**City of Douglas  
Wastewater Treatment Plant  
PV Solar Array Addition**

**ADDENDUM #2**

**Date: August 5, 2015**

SHEET **E1.2**  
 OF 2 SHEETS  
 JOB NO. A324

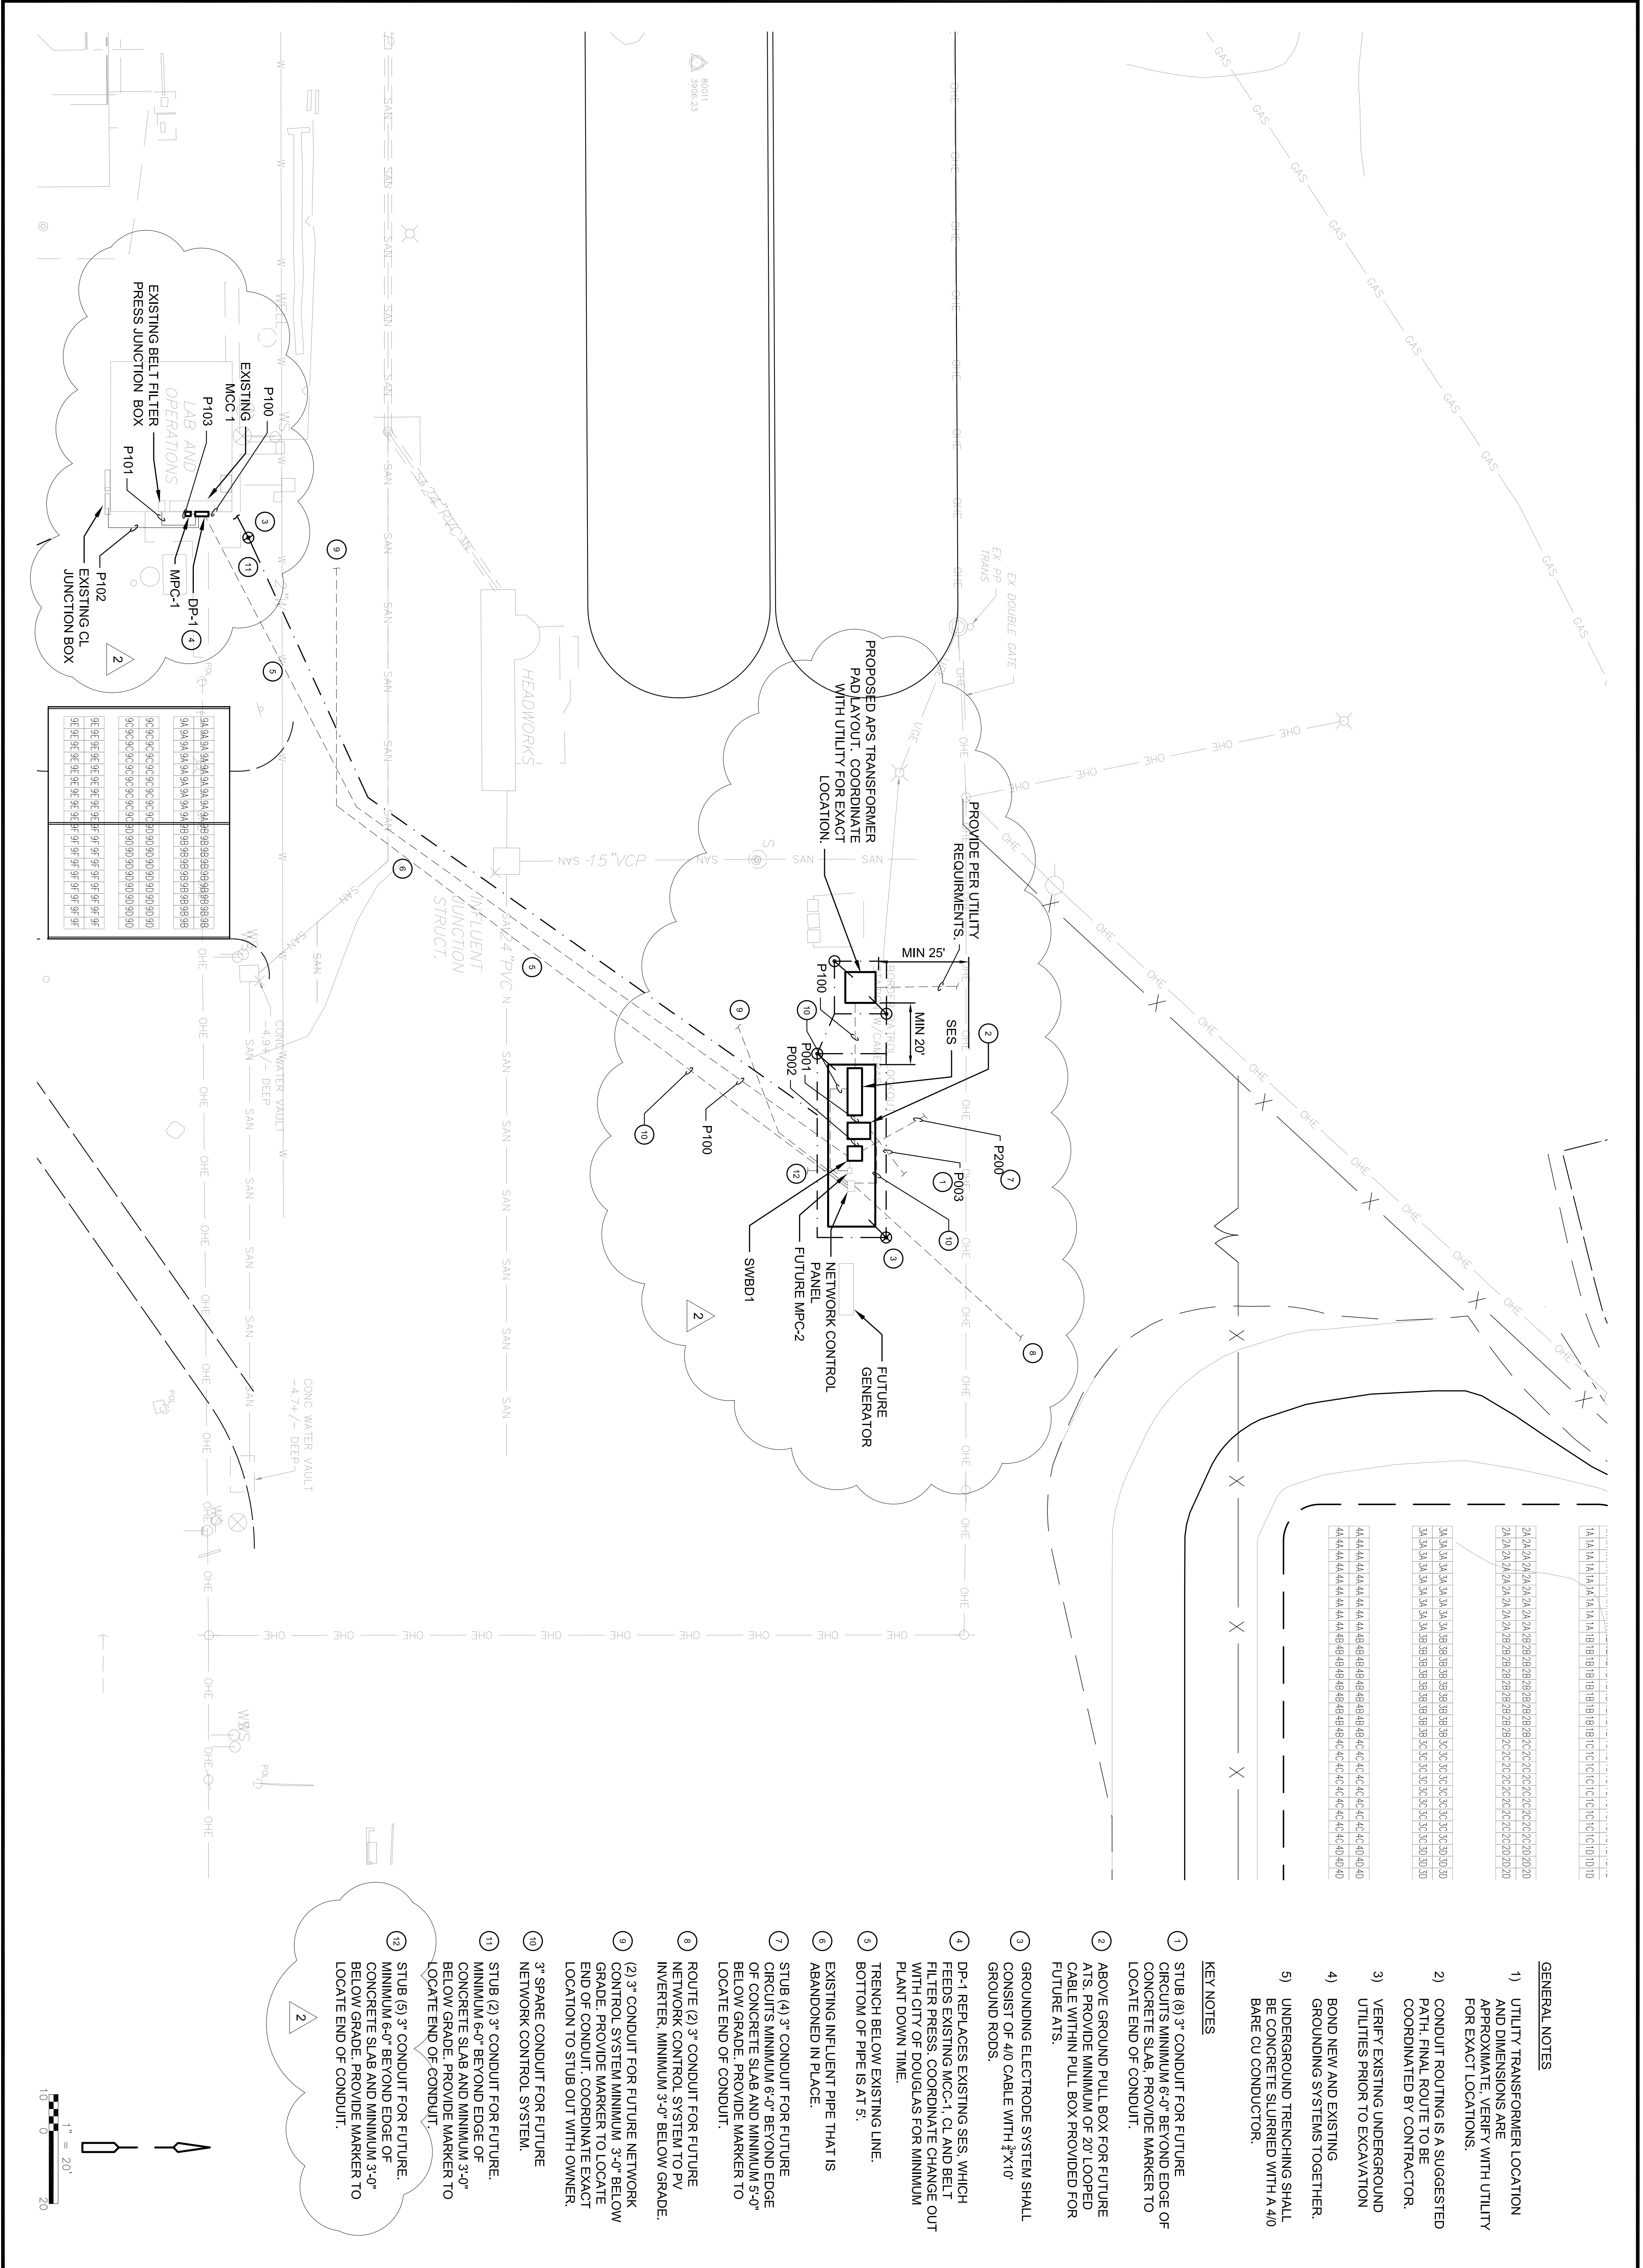
NO	BY	DATE	REVISIONS	DATE	APP.
1	BC	8/5/15	ELECTRICAL MODIFICATIONS
